(R) SCREW, MACHINE - HEXAGON HEAD,
DRILLED 1 HOLE, PD SHANK,
CRES AMS5731(UNS S66286), .1640-36 UNJF-3A

AS3106
SHEET 1 OF 2

REV.
A

FIGURE 1 - SCREW

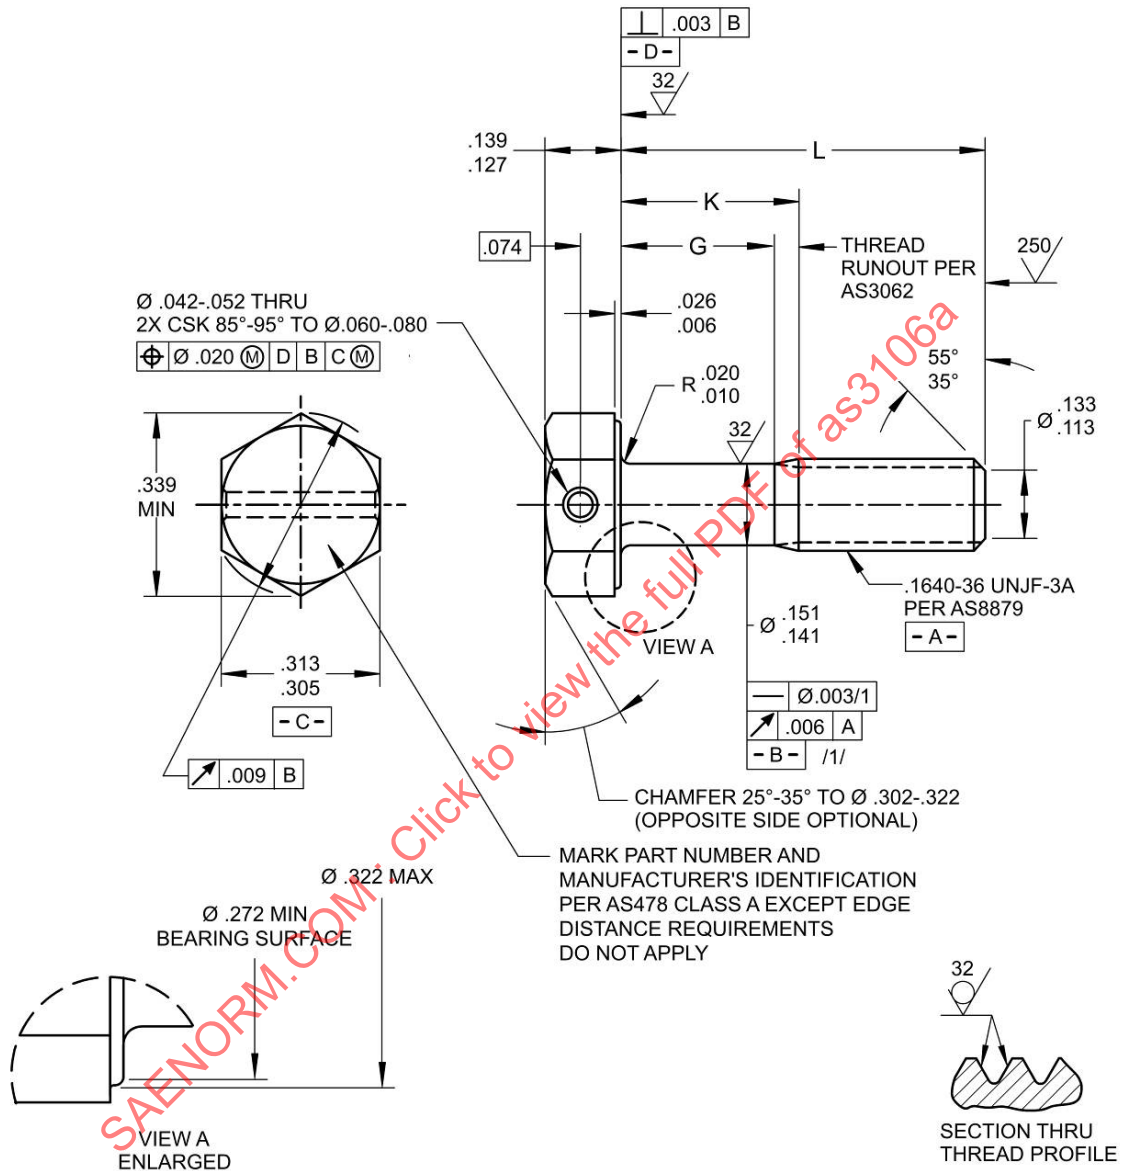
UPDATE THREAD SPECIFICATION TO AS8879, UPDATE TO ANSI Y14.5M-1982, REVISE FPI REQUIREMENTS TO ASTM E1417/E1417M, ADD TERTIARY DATUM IN HOLE POSITION FEATURE CONTROL FRAME, REVISE ACROSS POINTS DIMENSION, CHANGE DIMENSION FOR HOLE LOCATION TO BASIC, ADD EDGE DISTANCE EXCEPTION FOR HEAD MARKING, ADD AS3062 FOR THREAD RUNOUT, ADD SURFACE TEXTURE SYMBOLS PER ASME Y14.36M, REMOVE METRIC DIMENSIONS, FIGURE 1 REDRAWN AND GENERAL EDITORIAL UPDATE.
